ADDENDUM NO. 4**DATE: July 20, 2026**

PROJECT: HARMONY SCIENCE ACADEMY BRIDGELAND PHASE II MIDDLE-HIGH SCHOOL

**ARCHITECT'S PROJECT
NUMBER:** 06-22-014

NOTES:

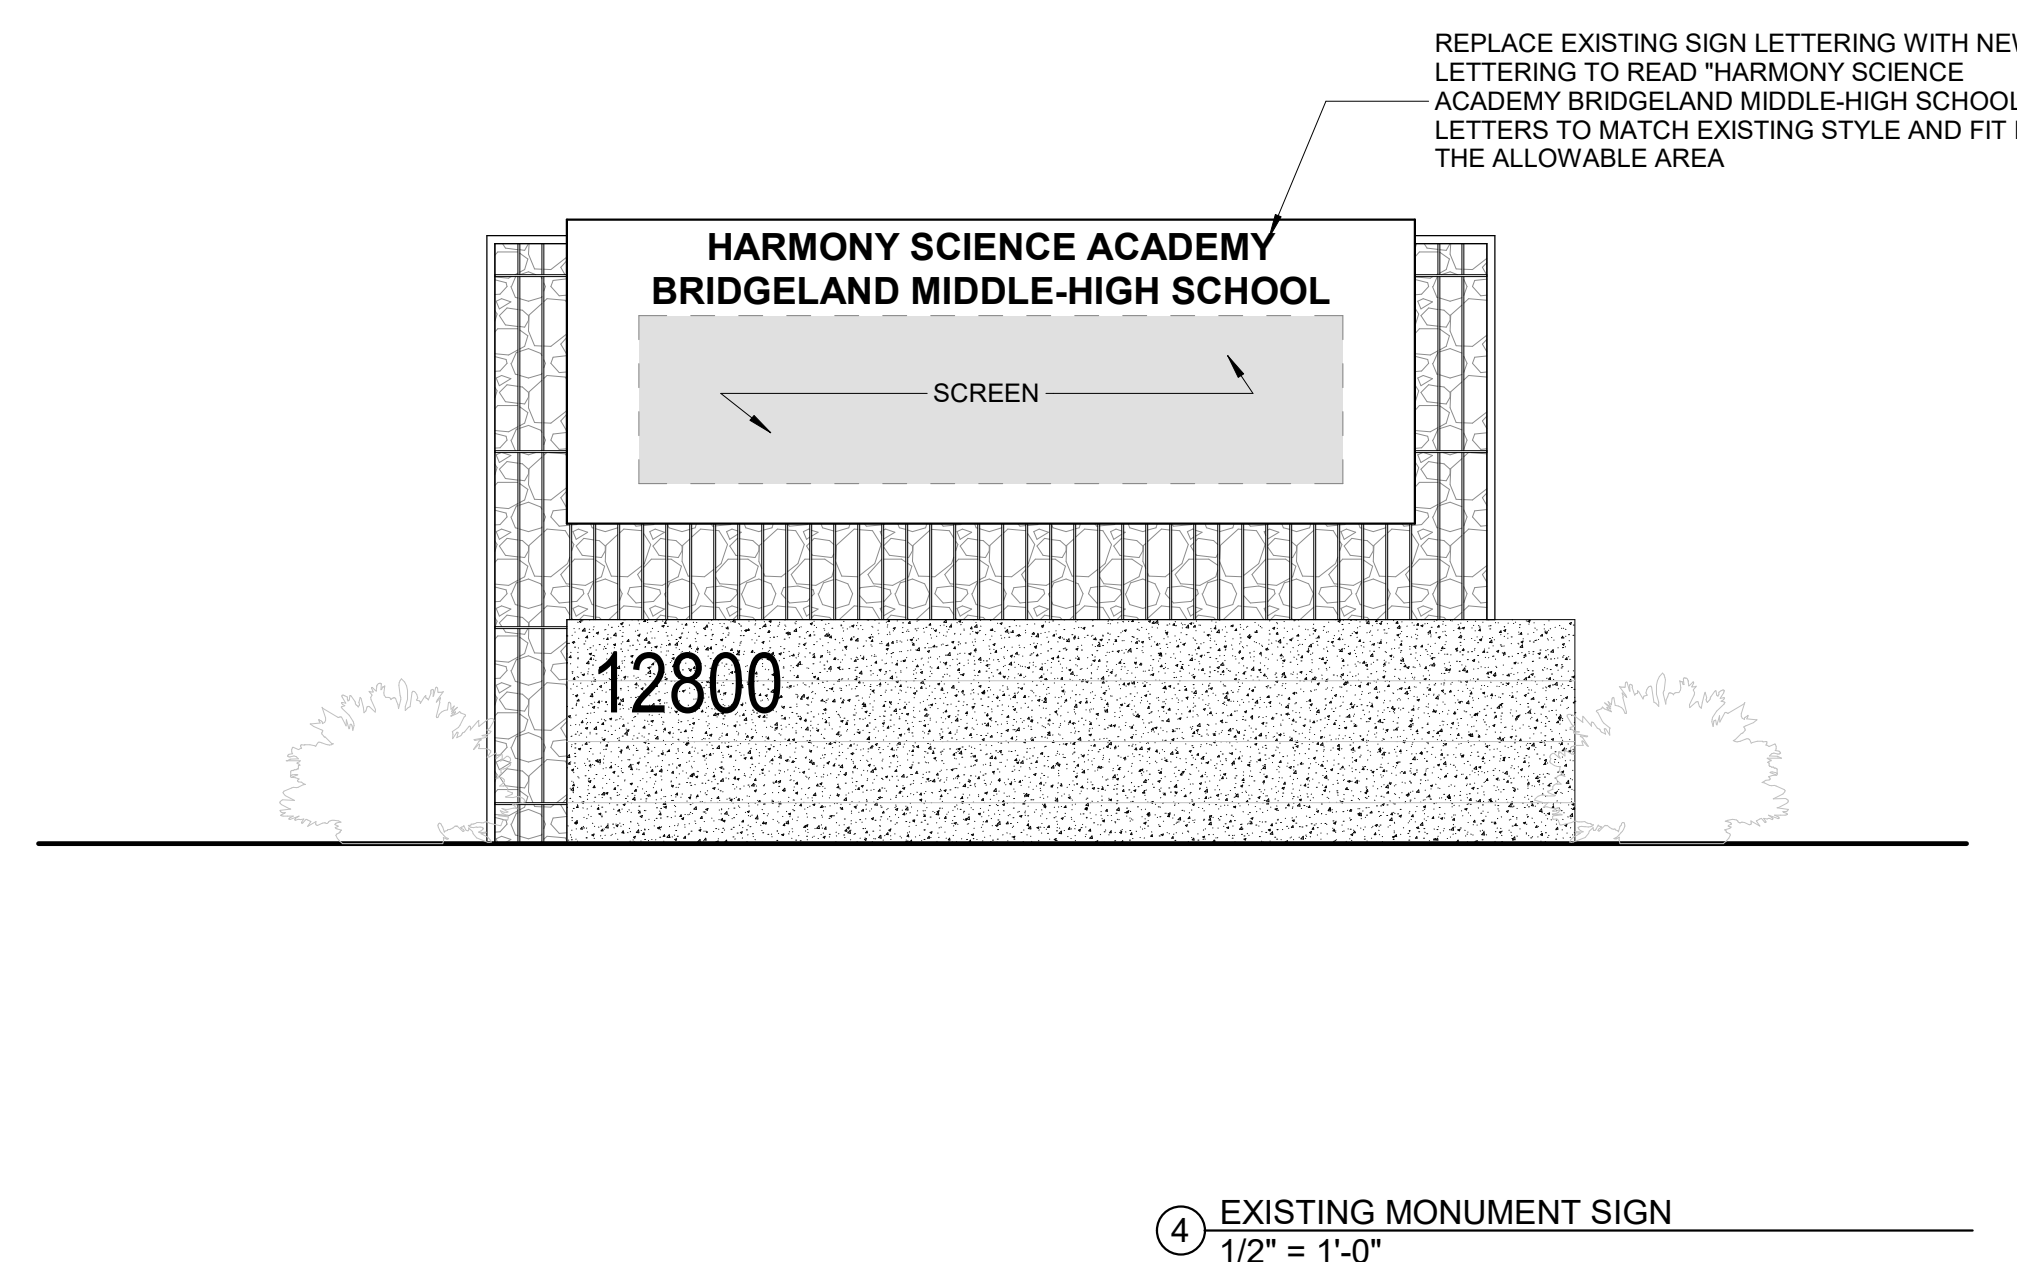
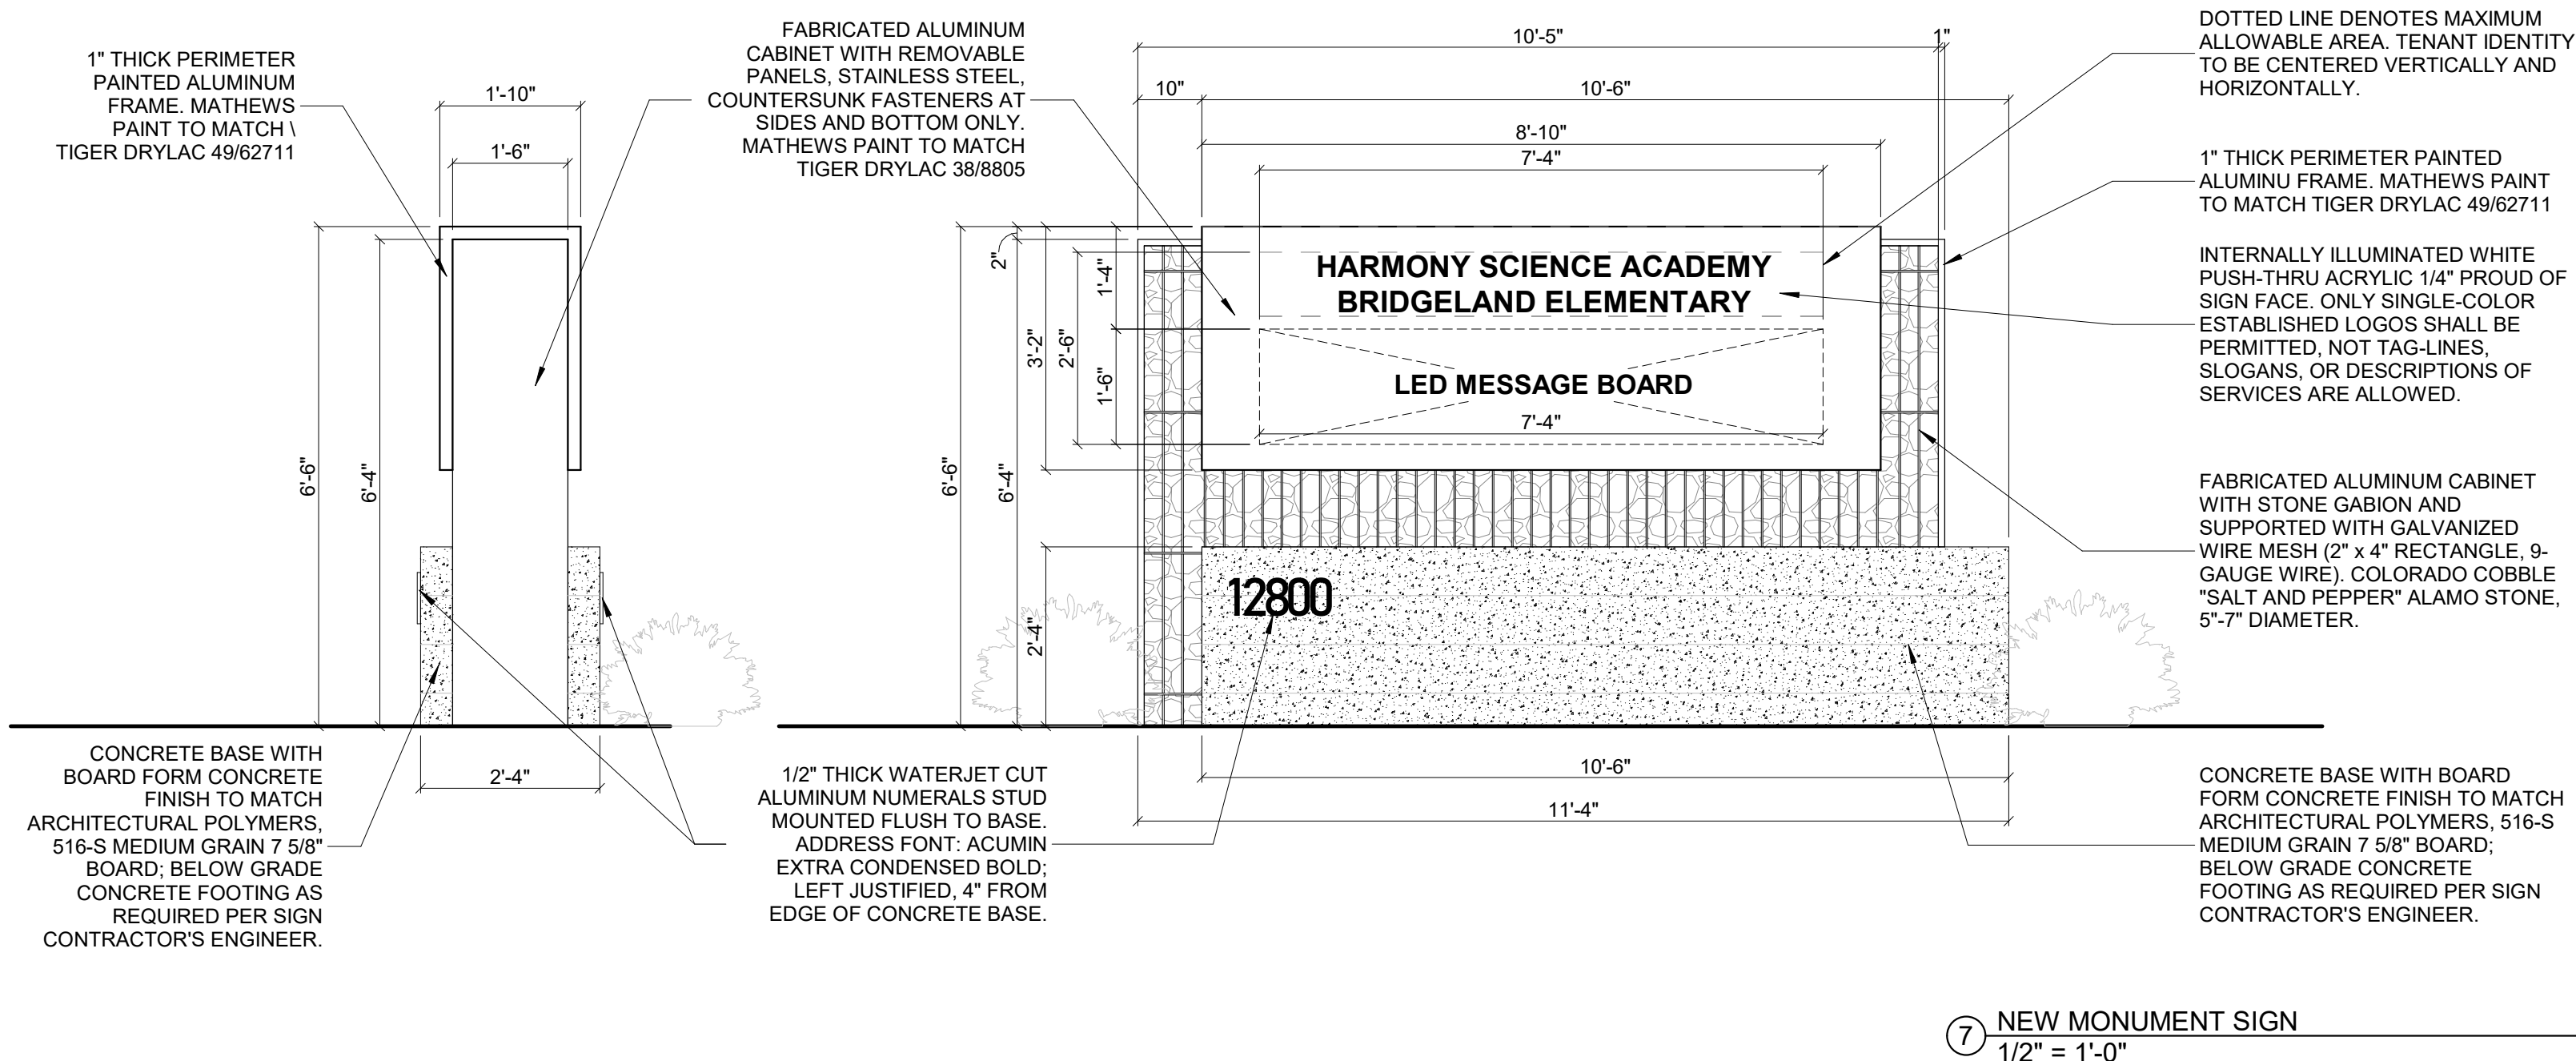
40. *Are any site furnishings such as trash receptacles, benches, tables, etc. required for this project? They have in the past but I don't see any on the plans.*

Response: Please see revised sheet A-002. There are 7 benches added and 3 trash cans.

Framing Plan -
High Roof Level -
Area A
S2.20A

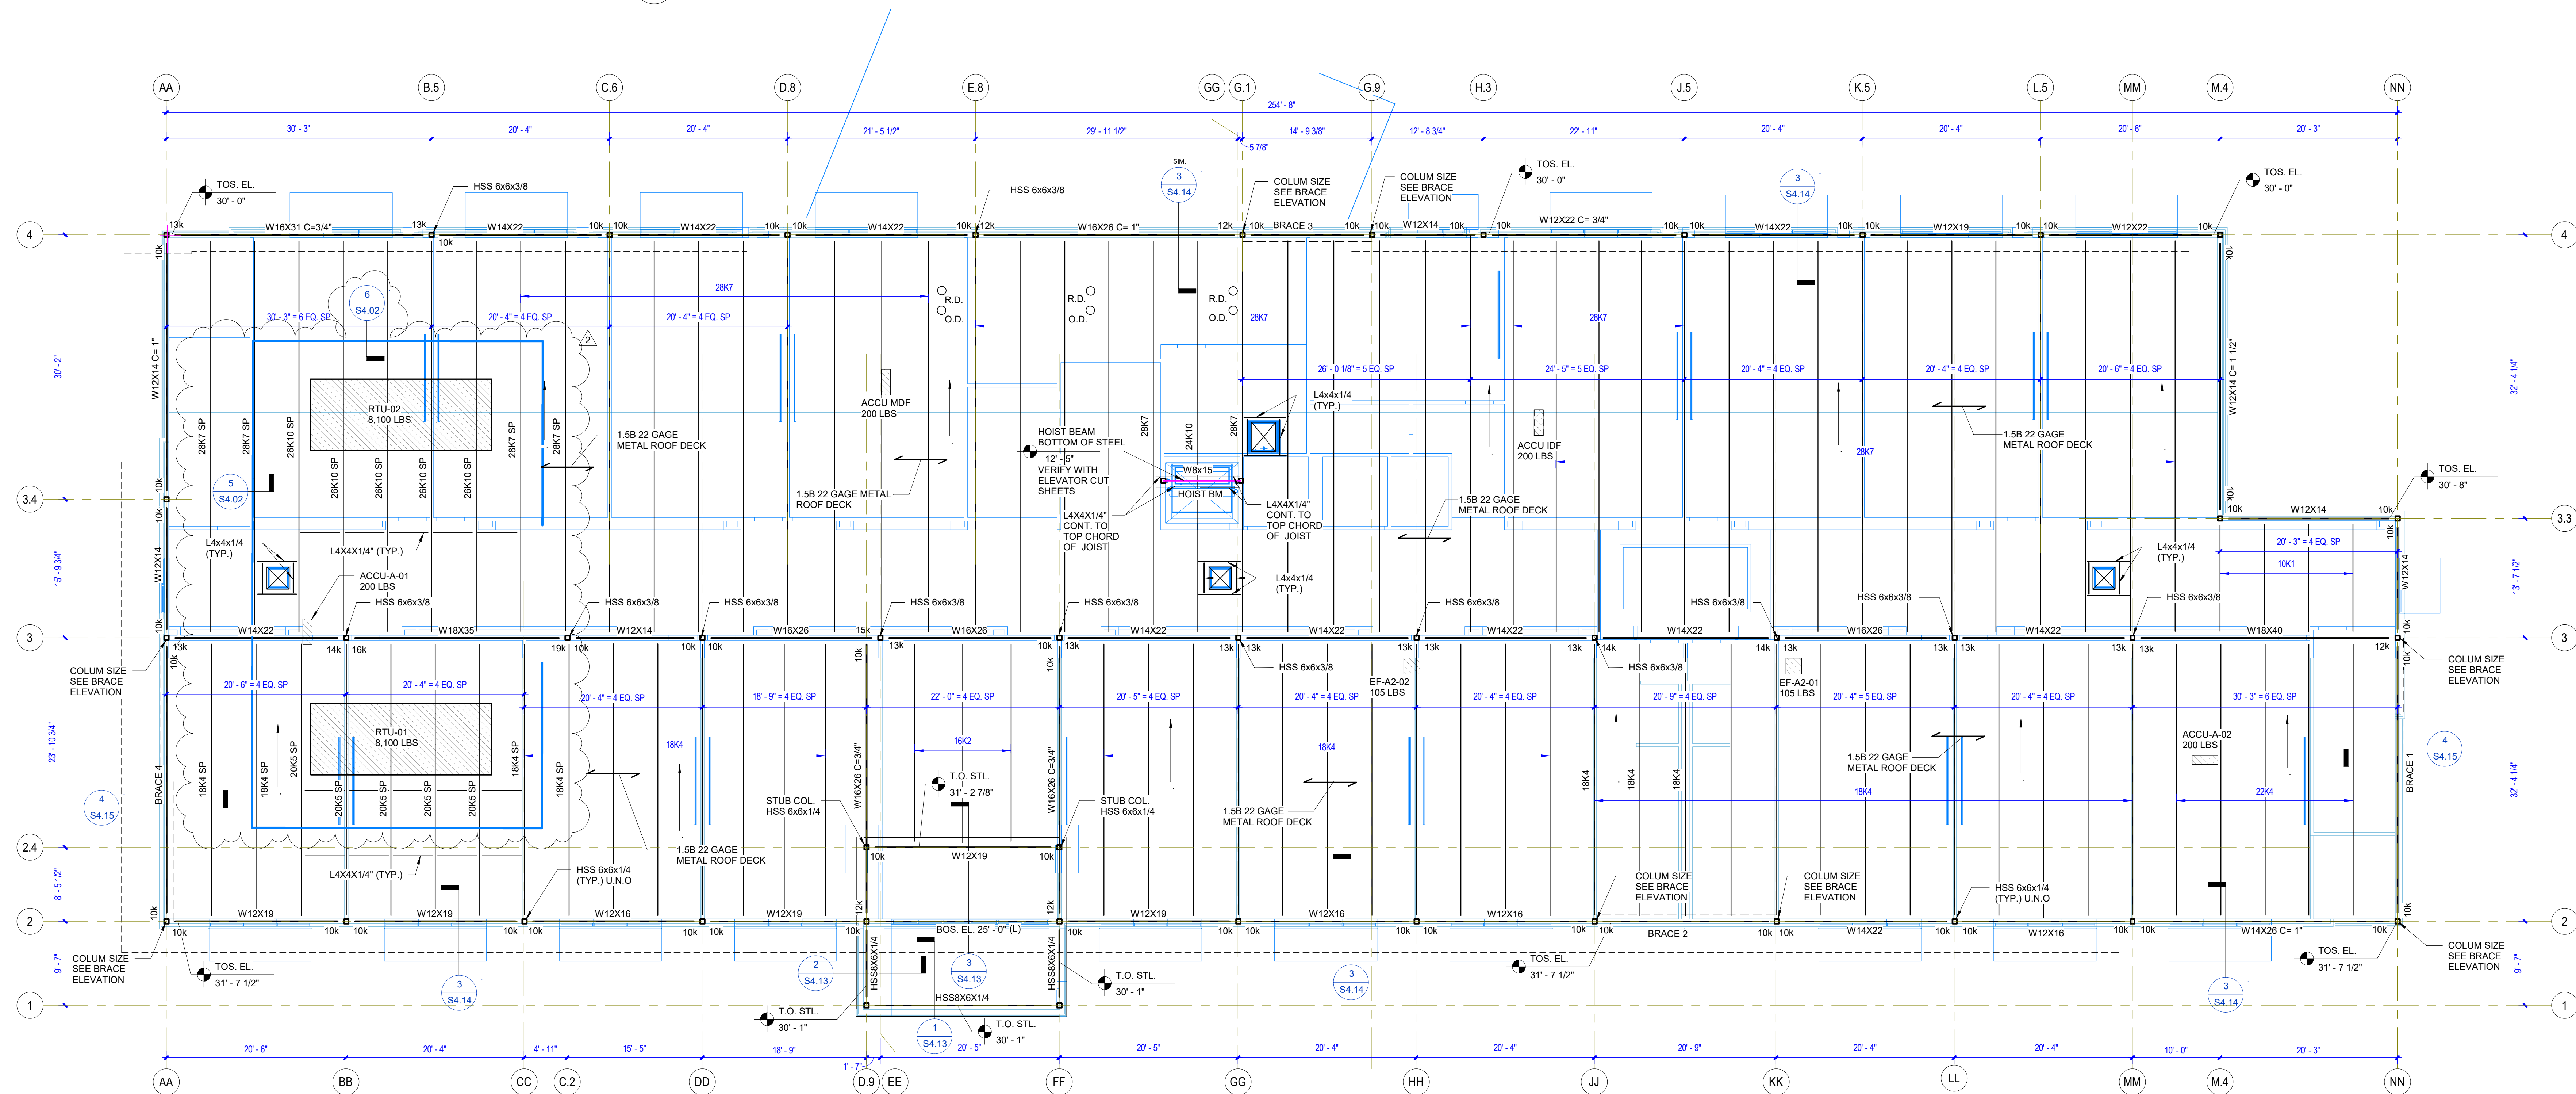
1. *2/S2.01A and 1/S2.20A does not show all roof screen framing that is shown on Sheet A1.30. Please confirm where roof screen framing is required on 2/S2.01A and 1/S2.20A.*

Response: Sheet S2.20A has been revised to show RTU screening locations.

8 Lightpole Foundation
3/4" = 1'-0"

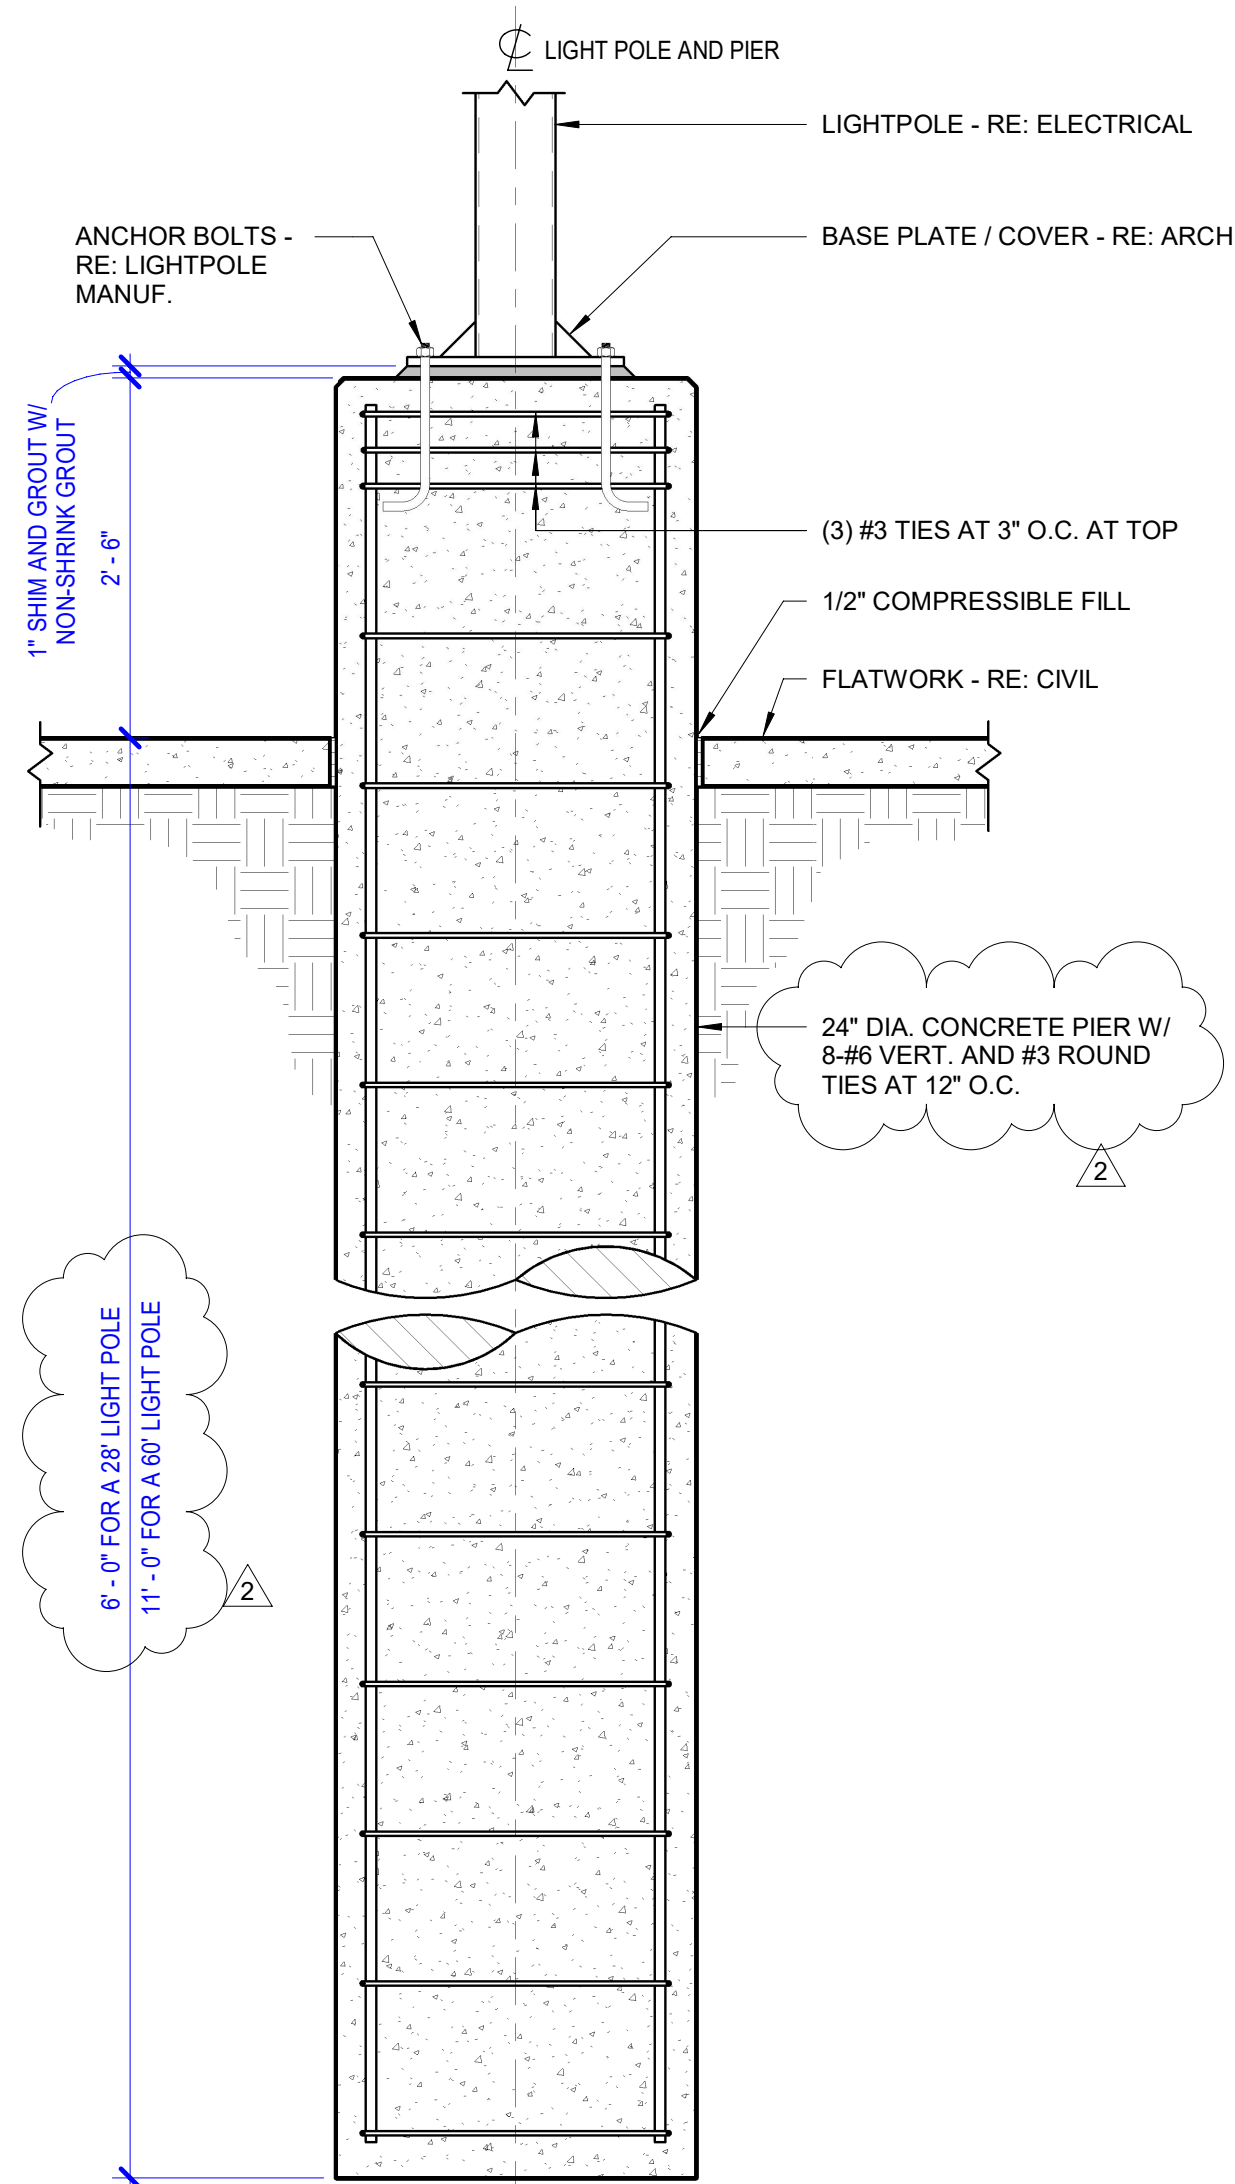
34. *Reference Sheet MEP-001: The drawings include a pole base detail for the standard light fixtures; however, no foundation detail is provided for the "OS" fixture, which is indicated as being mounted on a 60'-0" tall pole. Due to the increased height and loading requirements, the standard pole base detail may not be applicable. Please provide the required foundation/pole base detail and design criteria for the 60'-0" tall "OS" fixture, including any required anchor bolt pattern, reinforcing, and foundation dimensions.*

Response: Sheet S3.11 has been revised to show the foundation condition for both types of light poles on the project.

③ WEST ELEVATION - AREA 'A'
1/16" = 1'-0"

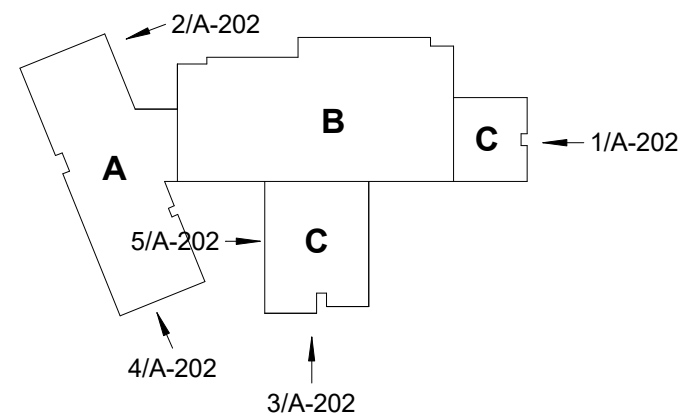
- 61.** *There's EIFS is called out on the exterior elevations (A-201 & A-202) to have a stucco finish, however there is no EIFS specification provided. Please confirm the extent of the EIFS and or stucco stucco scope of work and provide the necessary specifications.*

Response: The EIFS designation has been changed on the building elevations to STUC. These drawings show the extent of the STUC scope. Also see Wall Section 08 on sheet A-313. See Specification Section 09 2400 Cement Plastering related the STUC scope.
